AMENDMENTS TO THE DRAWINGS

FIG. 4

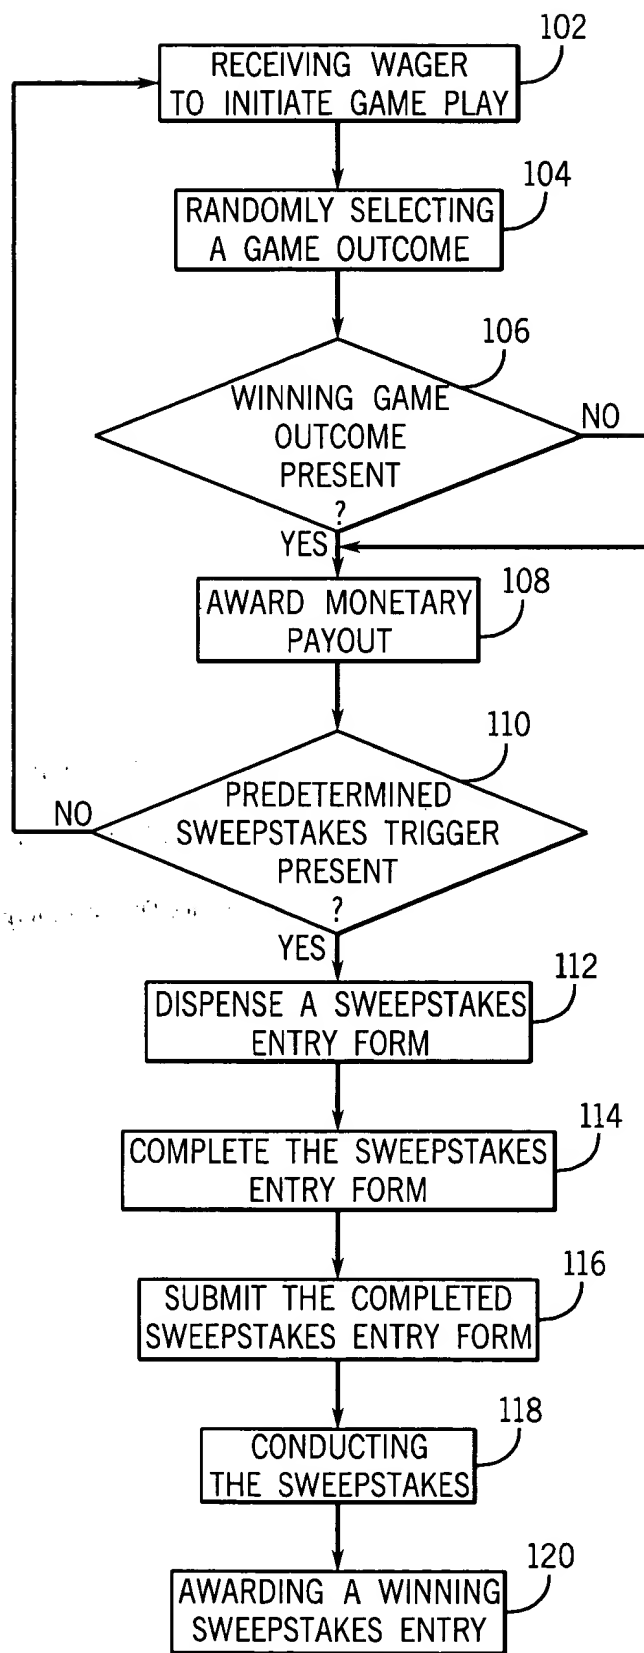
The drawings were objected to under 37 CFR 1.83 (a) on the basis that the drawings must show every feature of the invention specified in the claims. The Office Action further concluded that a block diagram showing the methods of claims 1, 3-4, 7, 14, 16, and 27-36 must be shown.

Applicant has drafted a figure of a block diagram containing each of the limitations described in the method claims (FIG. 4). This proposed drawing is being submitted to the Examiner for approval. Applicant believes that this drawing complies with the requirements of 37 CFR 1.83 (a) and overcomes the drawing objection.

OK TO ENTER
5/5/04
